Proposed Temporary Warehouses with Ancillary Open Storage Area for a Period of 3 Years / 擬議為期三年的臨時倉庫及附屬露天存放區

At Various Lots in D.D. 80 and Adjoining Government Land, Lin Ma Hang Road, Ta Kwu Ling, New Territories / 位於新界打鼓嶺蓮麻坑路 D.D.80 多個地段及毗連政府土地

Annex 3

Response to comment of Pre-submission

Figure 1

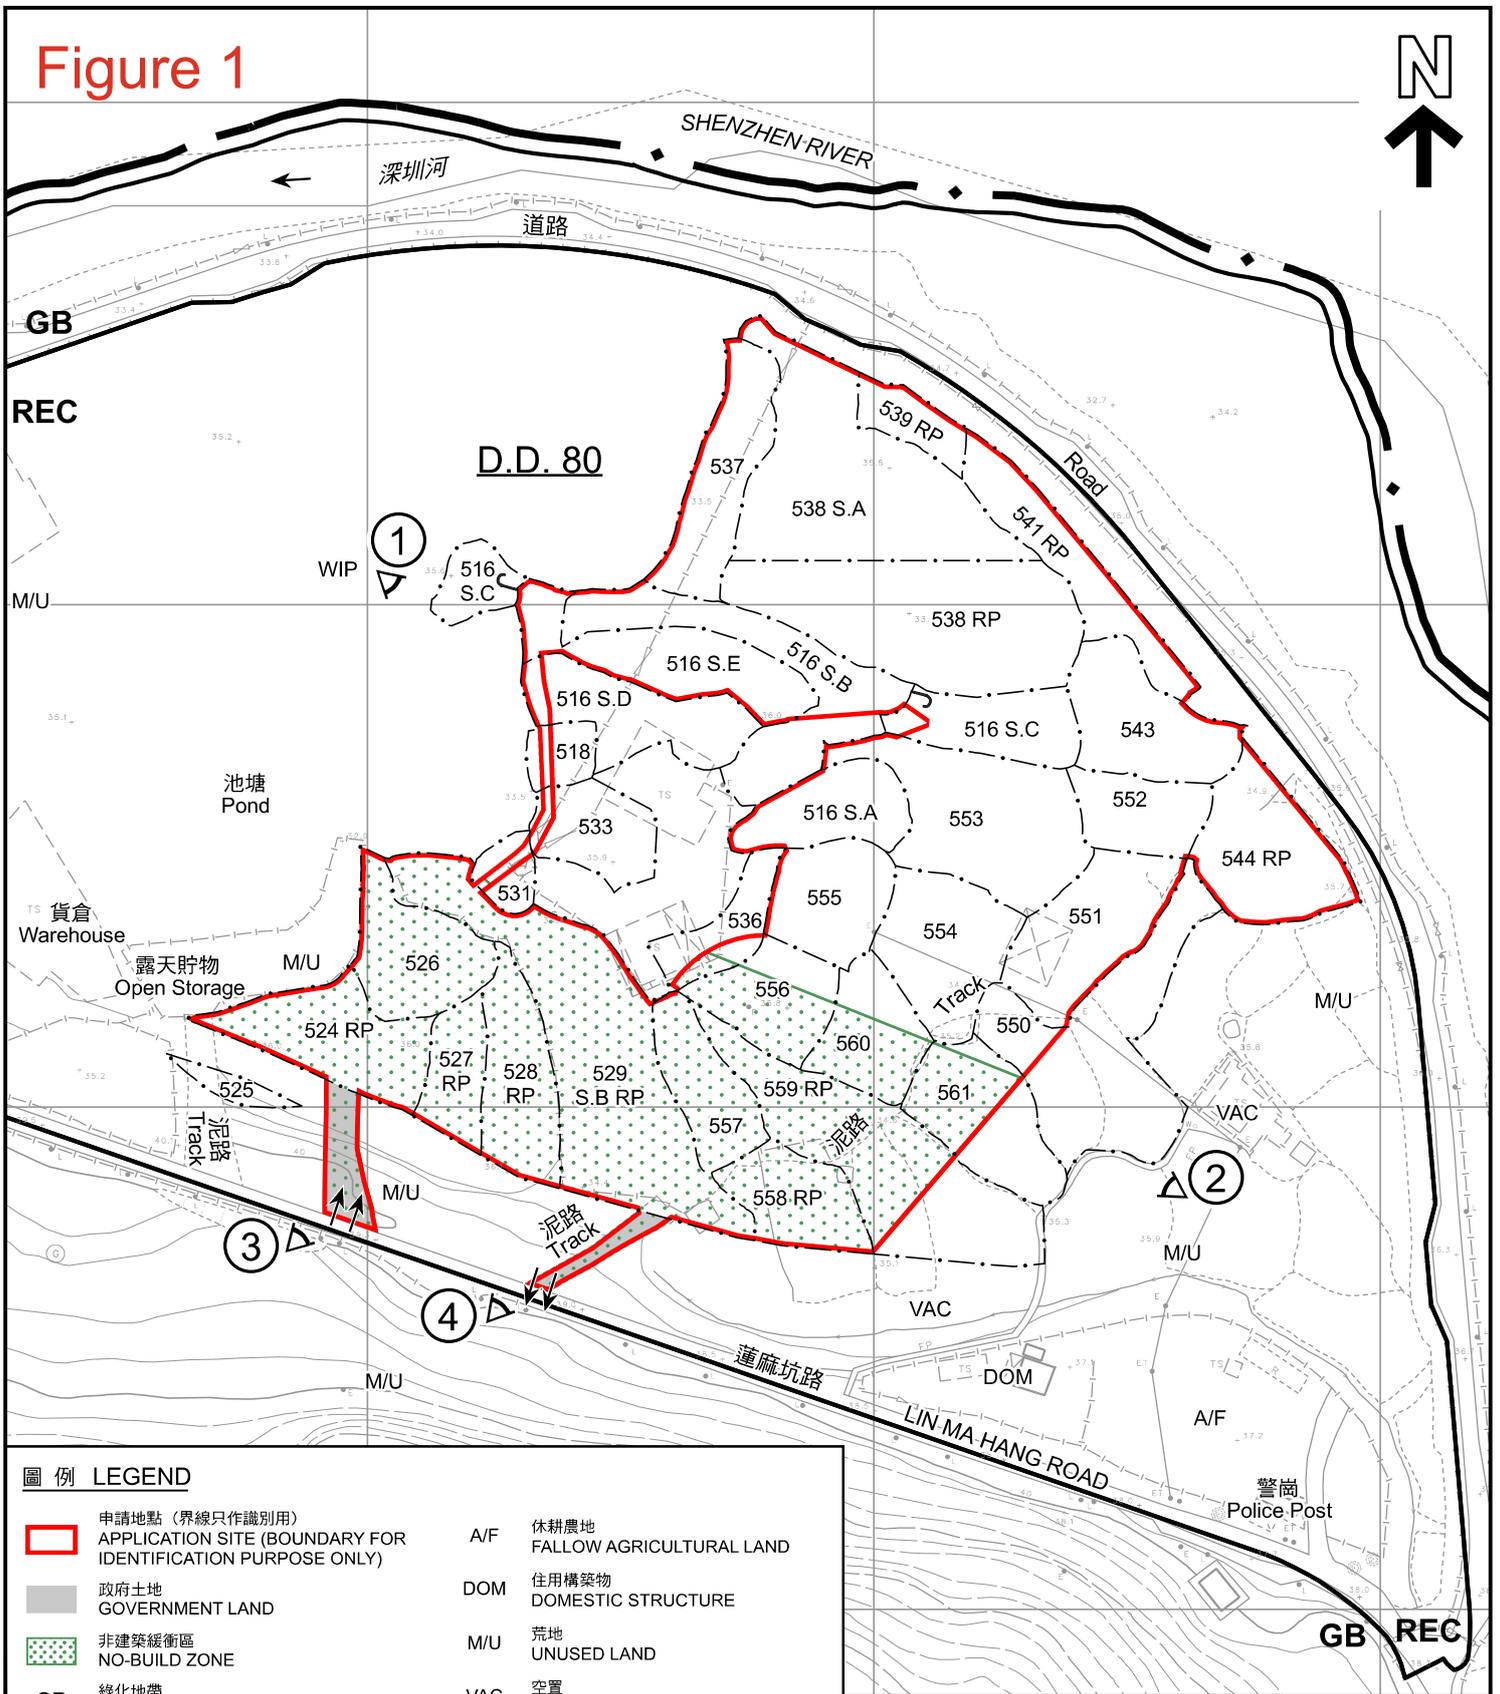
According to our information, it is noted that application No. A/HSK/313 (i.e. the original premises of Ms. LAM Mui) involves (i) storage of spare parts of fan and air-conditioning and (ii) storage of recyclable materials of metal (cans and scrap metal), while application No. A/NE-TKLN/89 (the relocated site of Chi Kee Sawmill & Timber Limited and Kin Hing Timber Engineering Limited) involves storage of timber and associated materials. However, it is mentioned in the pre-submission that the proposal involves some warehouses for storage of bulky items, large parts and equipment, and storage use without details, and an open storage yard for ancillary items (e.g. metal frames, steel pipes and other associated components). The nature of storage seems to be different from the original business operations. Please clarify. Also, please specify which warehouse structures and the open storage yard will be allocated to which affected business operations, and clarify if the warehouses and open storage yard will involve storage of dangerous goods;

1. Please refer to **Table 1** and **Figure 1** for detailed information. All the warehouses and associated open storage will not involve storage of dangerous goods.
